Reviewed for Code Compliance

HARNETT COUNTY
NORTH CAROLINA

SHEET DESCRIPTION	
COVER SHEET	
PROJECT #:	2018.037
DATE ISSUED:	12/14/2021
DRAWING BY:	JGM/BSJ
CHECKED BY:	PGC/DSC

**SERENITY AMENITY
GREENFIELD COMMUNITIES
CLUBHOUSE & POOL
Fuquay-Varina, NC**

SITE LAYOUT
1" = 60'-0"

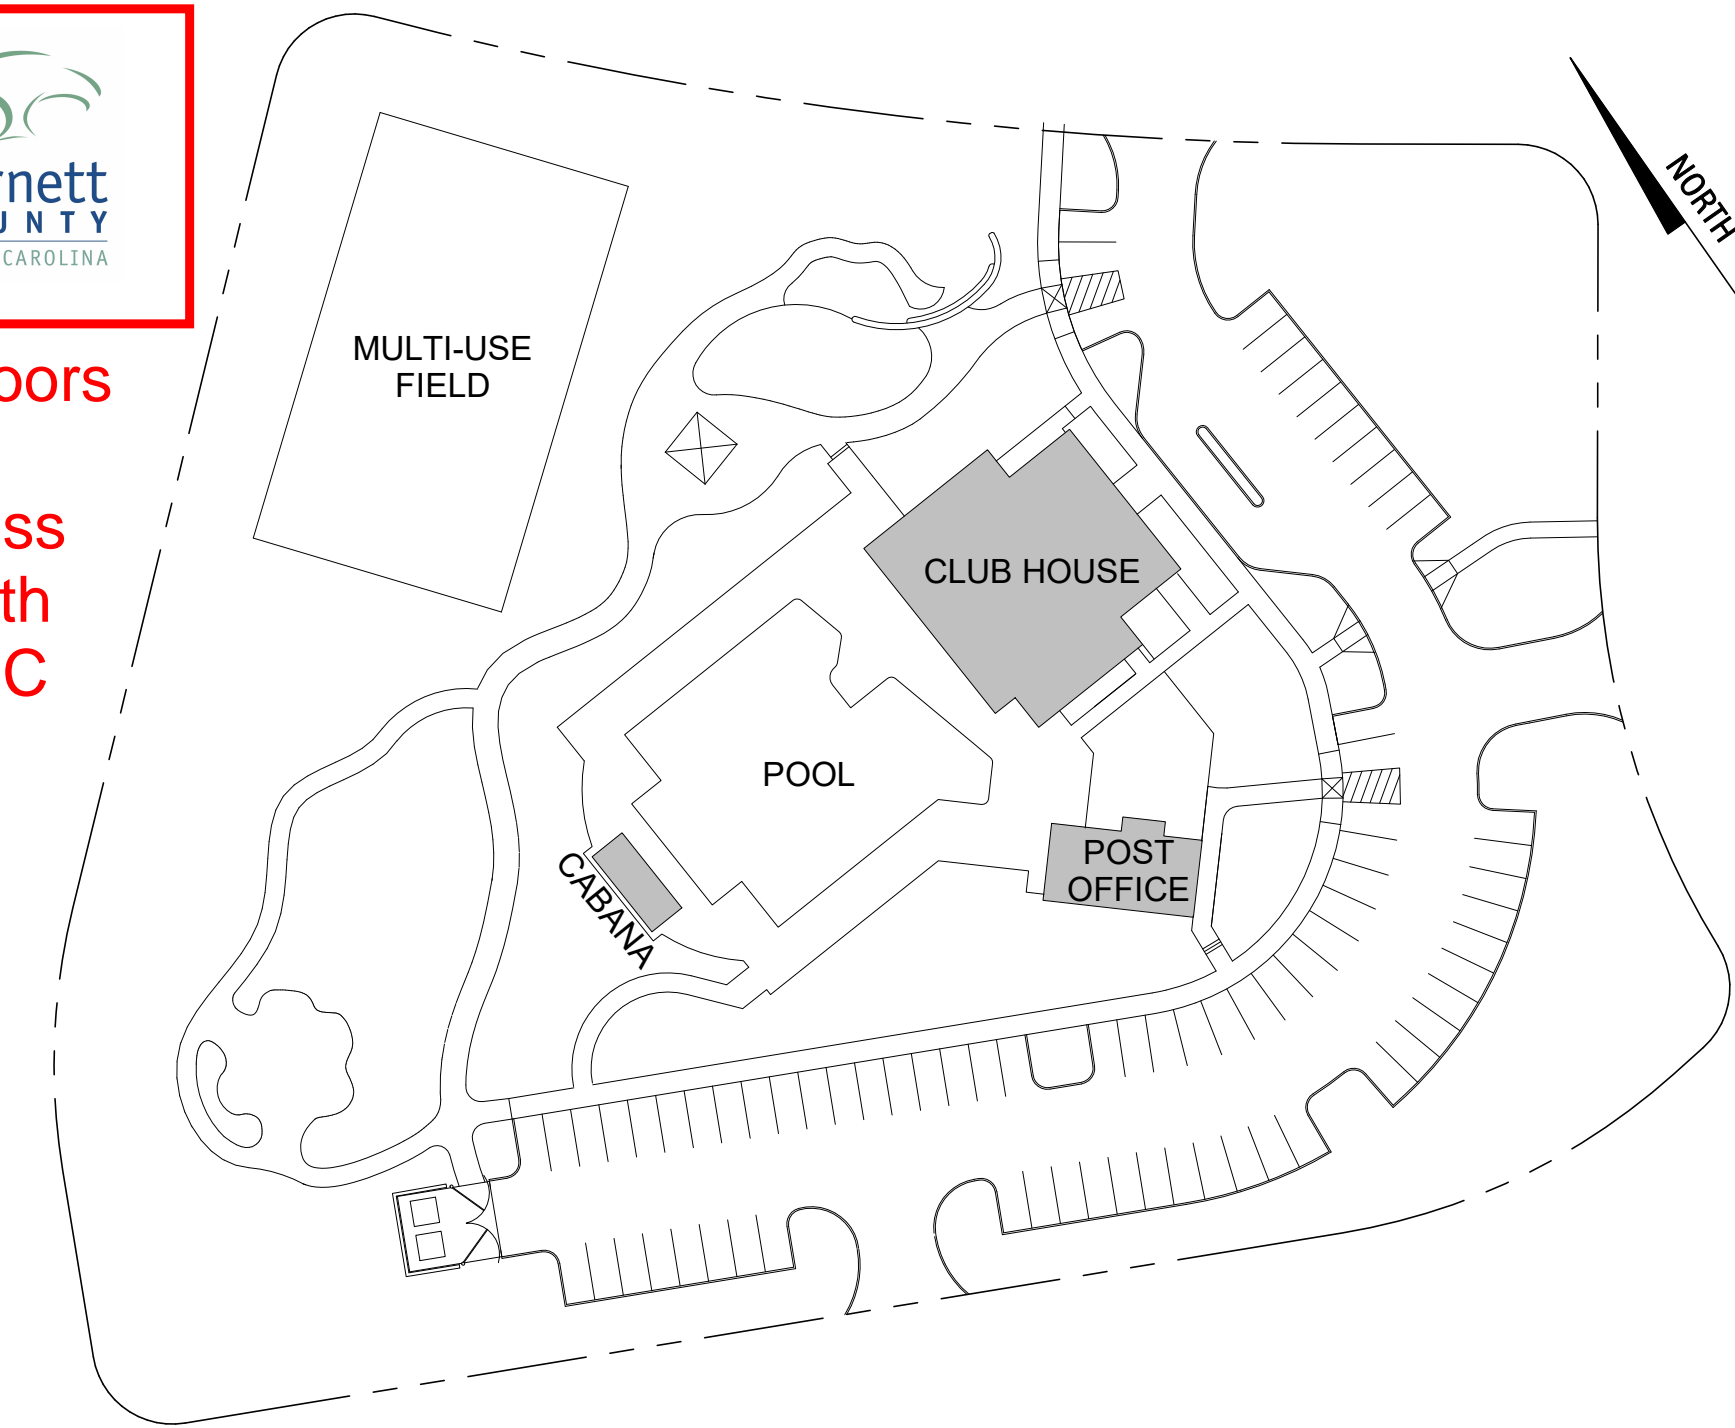
Clubhouse only. All doors with time locks shall operate from the egress side in accordance with 1010.1.9.9 2018 NCBC
